Highways Infrastructure Review: Pagham & Bersted, West Sussex

Objective: To examine whether community concerns and objections raised against planning applications for the Pagham district on grounds of lack of highways infrastructure are valid (or unfounded).

1: A27 / B2145 Whyke Roundabout
Mitigation Design Drawing JNY8840-19 (RPS)

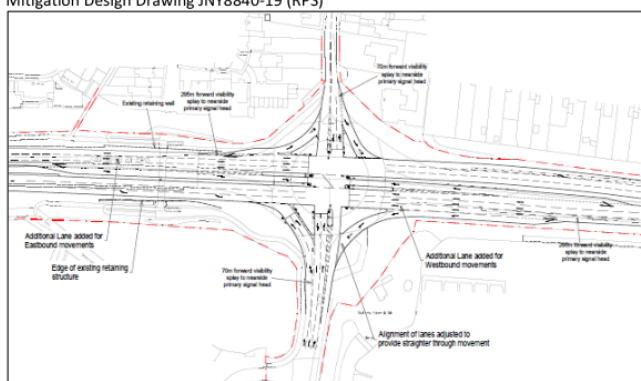
This diagram to the left is the A27/B2145 roundabout which will be wholly determined by Highways England under a separate s278 Agreement with each of 3 of developments identified, and which WSCC Highways Dept at time of preparing this report had no information. But separately the author has received confirmation from Highways England that the contribution is required to be paid on the occupancy of the 50th dwelling in each development, and that their scheme works will start to be rolled out 2025-26 through to 2029-30. But it remains still uncertain where exactly this junction is in the scheme of things and we reasonably suspect that it will get caught up in the continuing Chichester bypass debate.

- A27 ahead movements expanded from 2 to 3 lanes;
- A27 right turn reduced from 2 to 1 lanes
- Associated signal timing re optimisation

2: A27 / A259 (Bognor Road Roundabout)
SYSTRA Drawing No: 103800_D002 REV. - (First Version) (see Appendix F for formal drawing)
(Mitigations shown are in addition to those in Figure 1 on Page 18)

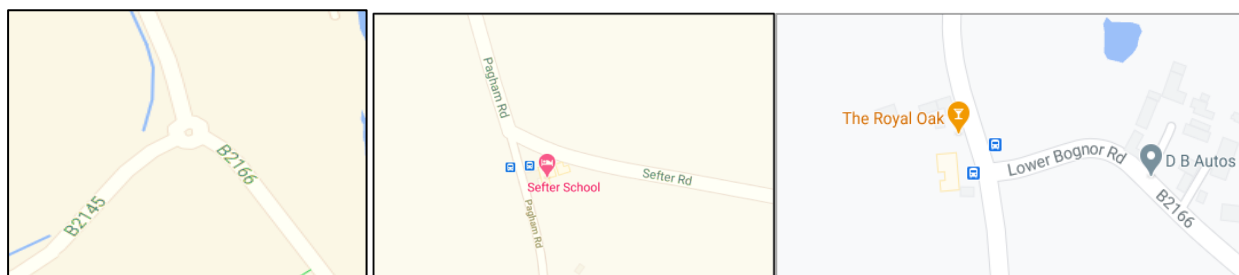
The proposal for Vinnetrov Road [diagram to right] will be making it an entry only off the roundabout (and not on to).

There is some suggestion that subsequently Vinnetrov Road may be redirected and reconnected to the A259 perhaps close to the Brick Kiln Garden Centre. But in the intervening period Berstead and North Mundham would become the only main outbound routes.

Removal of Vinnetrov Road permitted the inclusion of the A259(WB) to A27(SB) jet-lane. However this alone did not address approaches from A27(NB) which required signal control to remove the severe impact along with flare lengthening on this and the A259(EB) approaches. There remains marginal severe impact on the A259(EB) approach.

- New freeflow 'jet-lane' added from A259 westbound to A27 South/West bound
- Vinnetrov Road rerouted to a new signalised crossroads with A259 Bognor Road which also serves the Former Fuel Depot Site.
- Partial signalisation of A27 Northbound approach
- Lengthened Flares on A27 Northbound approach
- Lengthened Flares on A259 Eastbound approach
